TECHNICAL SERVICE BULLETIN

Illuminated MIL In Conjunction With Intermittent Transmission Shift Concerns In FORWARD Or REVERSE Gear With DTCs Stored - Transmission Wiring Harness With Wire Insulation Abrasion

26-2215

05 June 2026

E453994

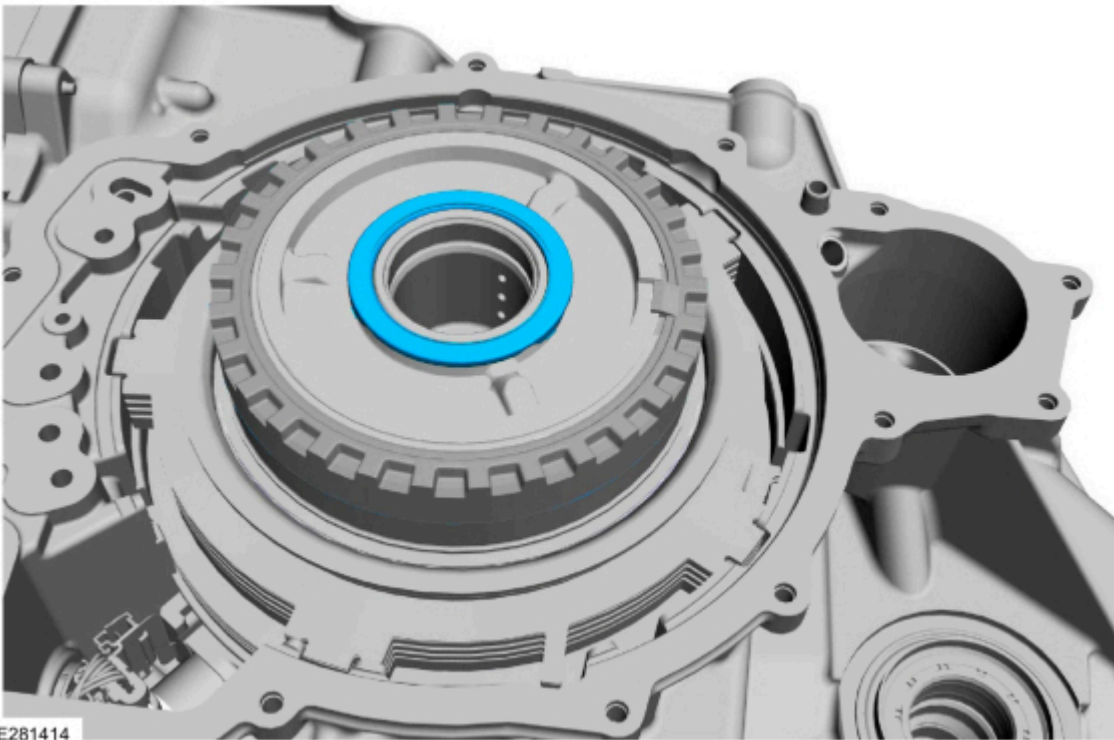
-  **CAUTION: Be extremely careful when removing the end cover. Take extra care not to drop / lose / damage the bearing sitting in behind (refer to next image).**

NOTE: Make sure that no component falls off during removal. Make sure the bearing is installed with flat side facing outwards.

Remove the transmission end cover. For additional information, refer to Transit Custom / Tourneo Custom Workshop Manual Section 307-01.

E281414

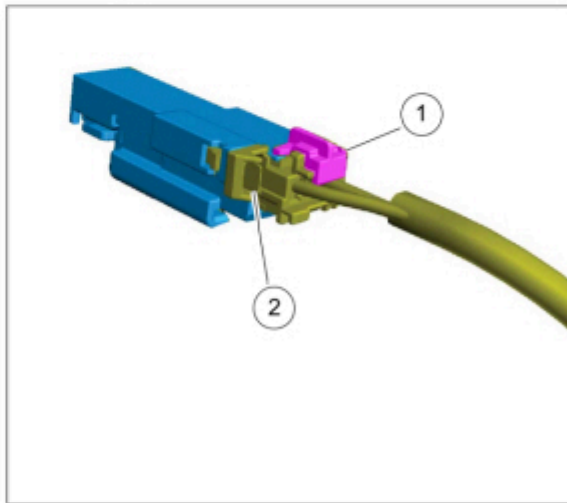
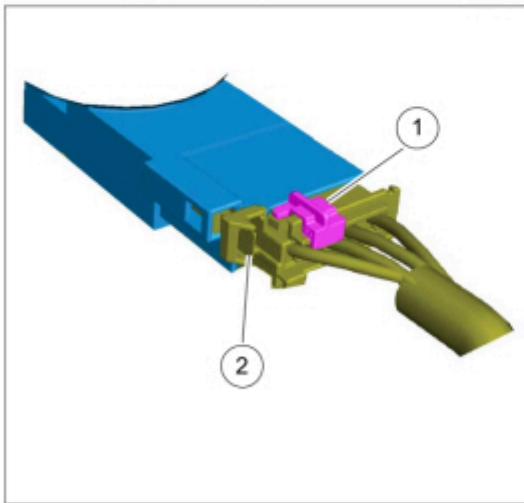
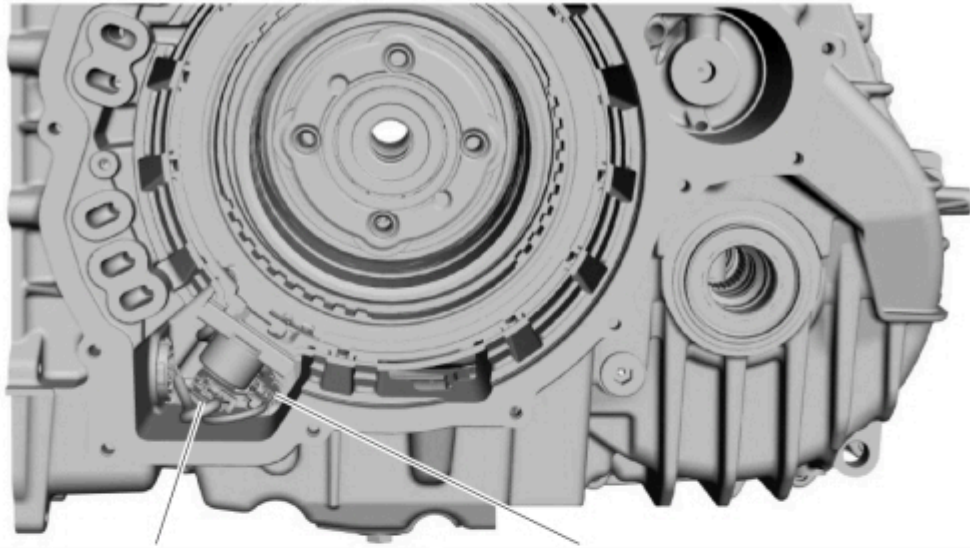
3. Inspect the exposed wiring for damage. If required disconnect the electrical connectors.

- If the abrasive damage to the wire is more significant, repair as required. For additional information refer to the corresponding workshop Manual Section on PTS.

E281624

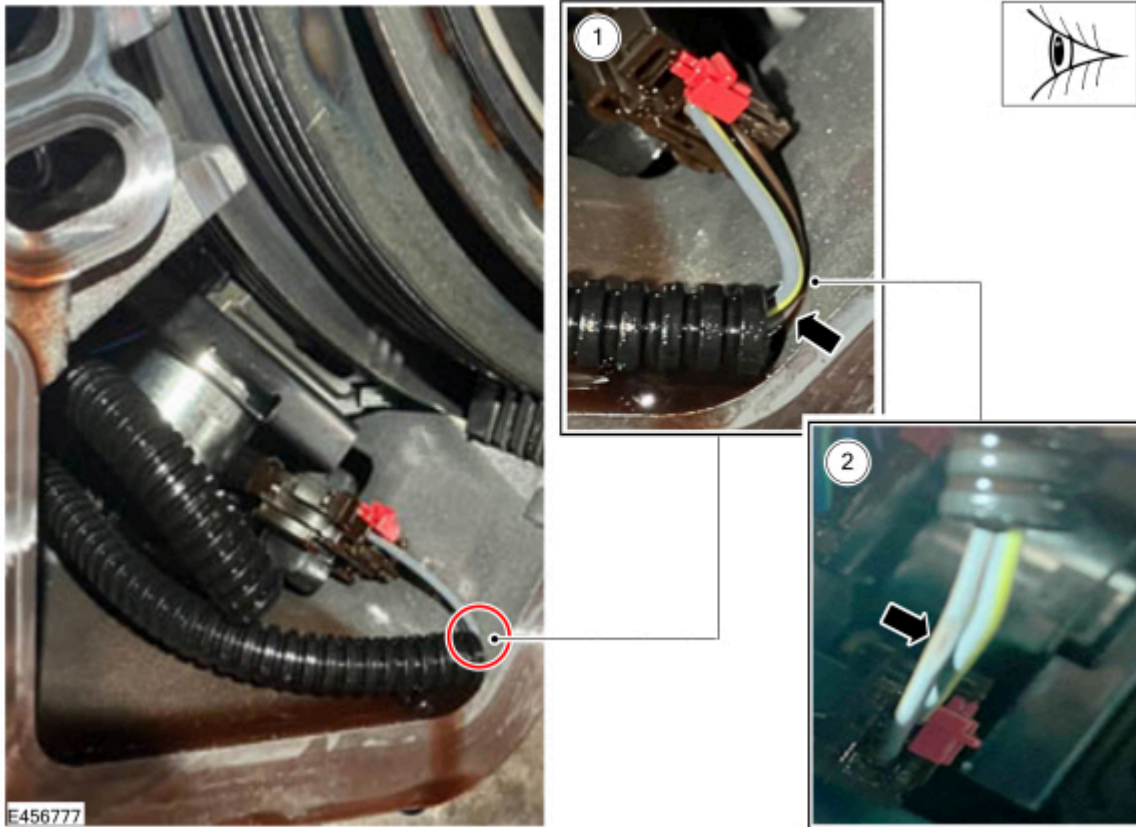
4. Example for transmission wiring harness with wire insulation abrasion.

(1). Electrical connectors connected to the transmission.

(2). Wire insulation abrasion.

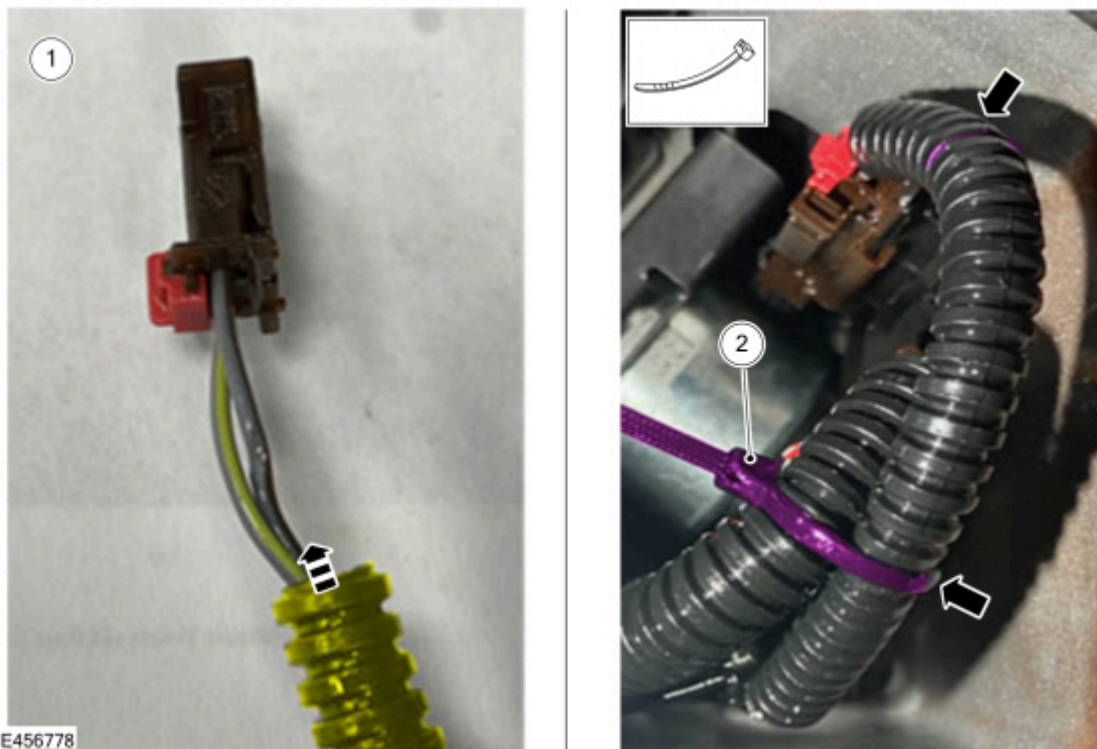
5. With the wiring harness still in the transmission pull the hard plastic convolute up close to the connector so it covers over the exposed wire.

(1). Hard plastic convolute

(2). Add small cable ties to hold the two adjacent convolutes together to prevent movement.
